Bridging Functional Insulation Implications and system consequences

802.3 Isolation Ad Hoc Meeting
Bridging Functional Insulation Contribution
Created by Mick Maytum

Functional Insulation — PE connections everywhere

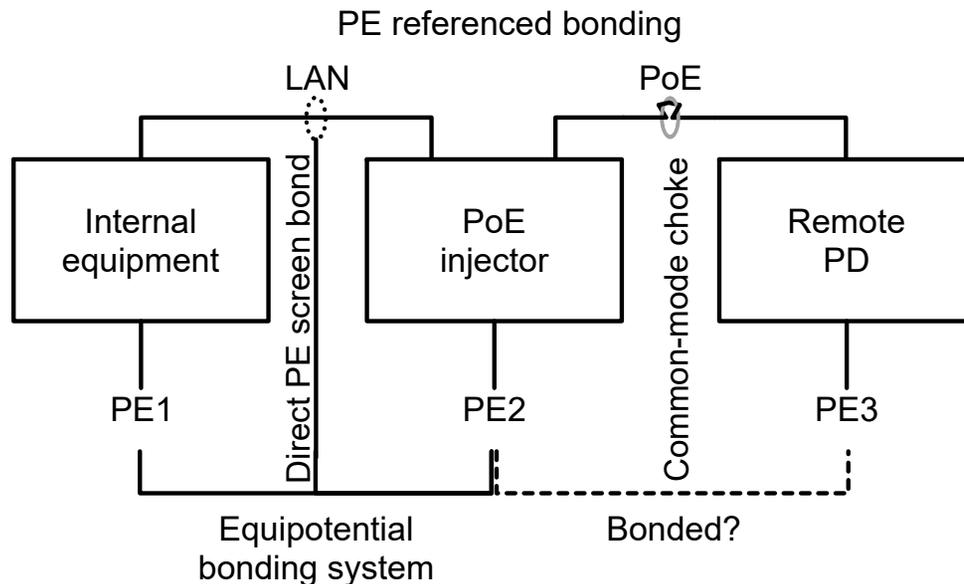
- The left remote AP connects the screen to the PE terminal and via a diode bridge the “isolated” circuitry (weather proof cover removed). Note the use of a functional earth symbol  and not the PE symbol 
- The right PoE injector connects the mains PE terminal to the LAN and PoE connector screens. The injector power source is also connected to PE

2018 PEG conference paper protected PoE injector

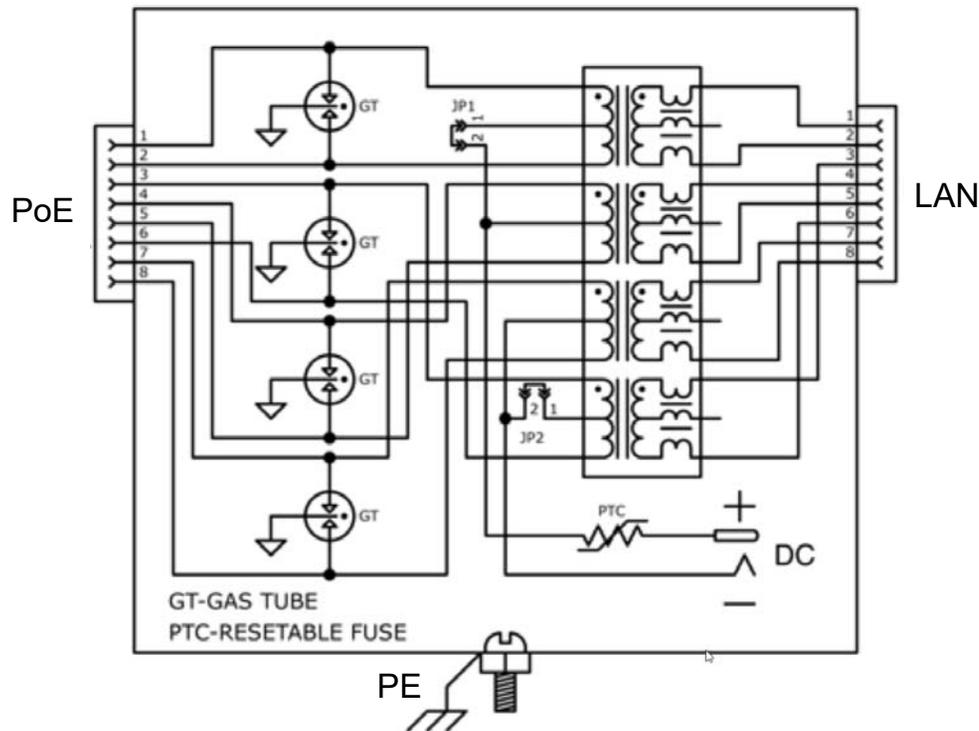
- Uses 90 V gas discharge tubes (GDTs)
 - PoE port will fail the IEEE 802.3 500 V insulation resistance test
 - Do not give the best lightning limiting voltage — a 150 V to 200 V type GDT is less.
 - Likely to be hazardous if power line contact occurs.
- Connects the PoE to PE in common-mode surge operation.
- No differential-mode surge protection.

PSE situation

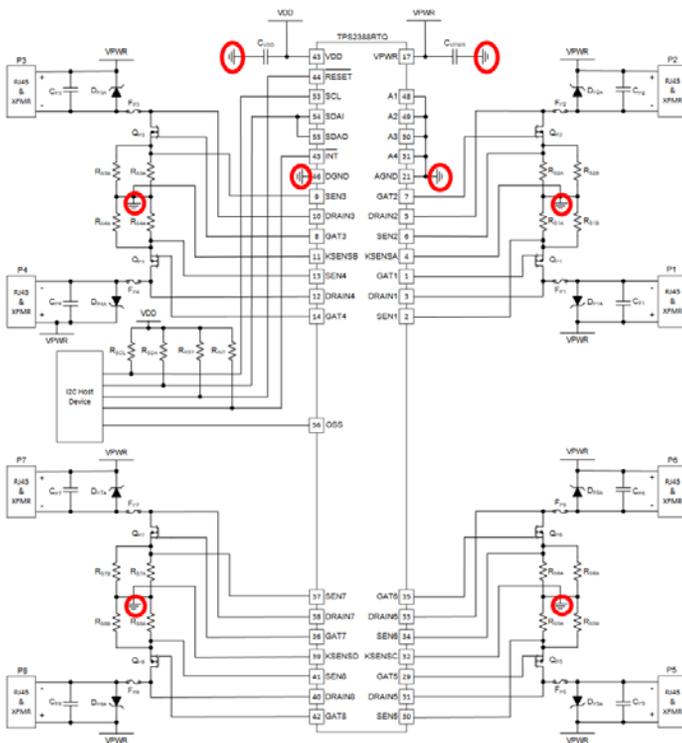
- The use of the earth symbol  (circled) implies that the PSE powering is connected to the PE system.
 - A better symbol would be functional equipotential bonding  (Chassis in vacuum tube days)
- A common power supply to all ports has led to an incoming surge to one PoE port exiting via another PoE port. This has caused field failures.
 - Full description and some fixes given in [*Power Over Ethernet \(PoE\) Part 2 - Protecting PoE Against Intra-Building and OSP Environments*](#) by Tim Ardley, 2015 PEG Conference
